**Office Action Summary**

10/501,537

KNOLL, ISTVAN

## **DETAILED ACTION**

**FIG. 6**

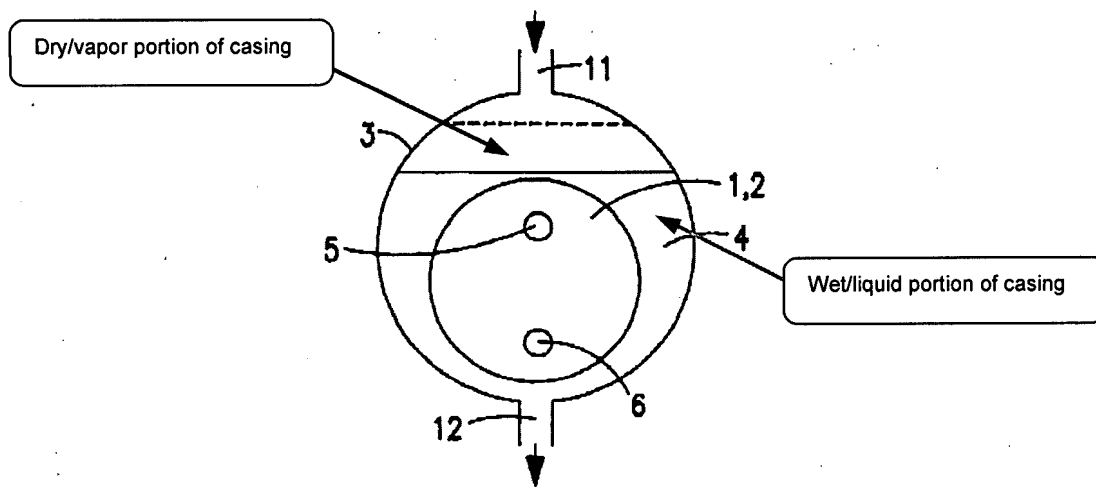
Regarding claim 1, Lampinen et al. disclose a submerged (as seen in the illustration of Figure 6 below) evaporator (1, 2 – plate heat exchangers) contained in a casing (3 – shell) and including at least one integrated plate heat exchanger (heat exchangers [1, 2] are integrated with respect to the connectors [5, 6, 7, 8]; Figure 6), where the integrated plate heat exchanger has at least one inlet connection (5, 7 – connectors) and at least one outlet connection (6, 8 – connectors) for a secondary refrigerant (as seen in Figure 6), where the plate heat exchanger is disposed at the bottom of the casing (as seen in Figure 6), where a primary refrigerant (water) may flow around the plate heat exchanger (see col. 6, lines 24-34, 65-67) and a secondary refrigerant may flow through the plate heat exchanger (see col. 6, lines 43-50), and where the uppermost part of the casing is

used as a liquid separator (as seen in Figure 6), wherein the integrated plate heat exchanger is integrated with the evaporator (as seen in Figure 7) and made with an outer contour that substantially follows the lower contour of the casing and the liquid level of the primary refrigerant (as seen in Figures 6, 7).

Regarding claim 2, Lampinen et al. disclose the longitudinal sides of the plate heat exchanger are closed for inflow or outflow of the primary refrigerant between the plates of the plate heat exchanger (as seen in Figures 6, 7), and wherein the bottom of the plate heat exchanger there is provided at least one opening through which the primary refrigerant flows in between the plates of the plate heat exchanger (as seen in Figure 7).

Regarding claim 10, Lampinen et al. disclose the casing contains a suction manifold (21 – dispersing plate) disposed in the "dry" part (as seen in the illustration of Figure 6 above) of the casing and extending in longitudinal direction of the evaporator with a length substantially corresponding to the length of the plate heat exchanger (as seen in Figure 6).
